Item Name: Baggage Compartment Protector - Floor And Wall

DART SERVICE INSTRUCTION

TO AMEND INSTALLATION INSTRUCTIONS IIN-D407-781-2 REV. A OR LATER APPROVED REVISION
AND INSTRUCTIONS FOR CONTINUED AIRWORTHINESS ICA-D407-781 REV. 3 OR LATER REVISION

REF. TCCA STC: SH08-60
REF. FAA STC: SR002726NY
REF. EASA.IM.R.S.01541

**FIGURE 1 - D3879-1 BAGGAGE COMPARTMENT WALL
PROTECTOR - ALTERNATE INSTALLATION**

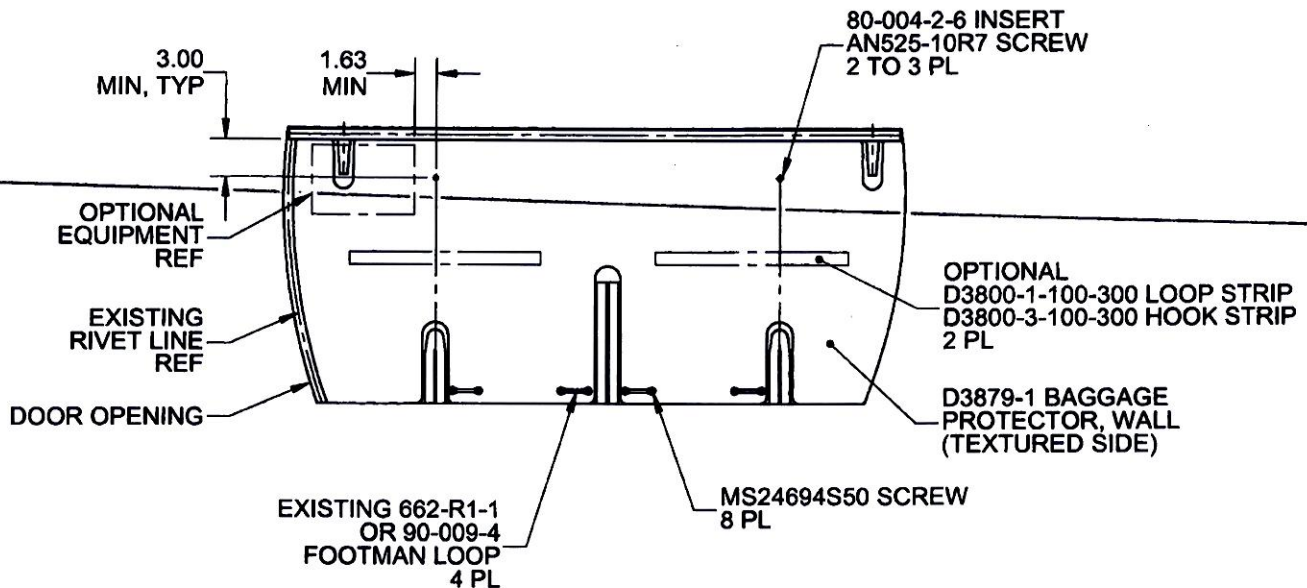
In some aircraft, the top portion of the D206-781-041 Baggage Compartment Wall Protector Kit cannot be installed as indicated in IIN-D407-781-2. The purpose of this DSI is to provide an alternate mounting method to fasten the top portion of the D206-781-041 Baggage Compartment Wall Protector Kit.

It is acceptable to replace qty(2) D3930-1 Clips with qty(2) 80-004-2-6 Inserts. Locate and mark location of the two attachment holes on the baggage compartment wall as shown in Figure 1 of this service instruction. Install 80-004-2-6 Inserts at the marked locations in accordance with Section 3-2-12 of BHT-206-SRM-1. It is acceptable to trim the wall protectors to accommodate optional equipment or transfer attachment holes to the wall protector and install the optional equipment on top of the wall protector with longer fasteners.

Amend the D206-781-041 Baggage Compartment Wall Protector Kit parts list as follows:

Qty -061	Qty -031	Qty -041	Part Number	Description
X			D206-781-061	BAGGAGE COMPARTMENT PROTECTOR KIT (FLOOR AND WALL)
1	X		D206-781-031	BAGGAGE COMPARTMENT FLOOR PROTECTOR KIT
1		X	D206-781-041	BAGGAGE COMPARTMENT WALL PROTECTOR KIT
		2	AN525-10R7	SCREW
		2	80-004-2-6	INSERT
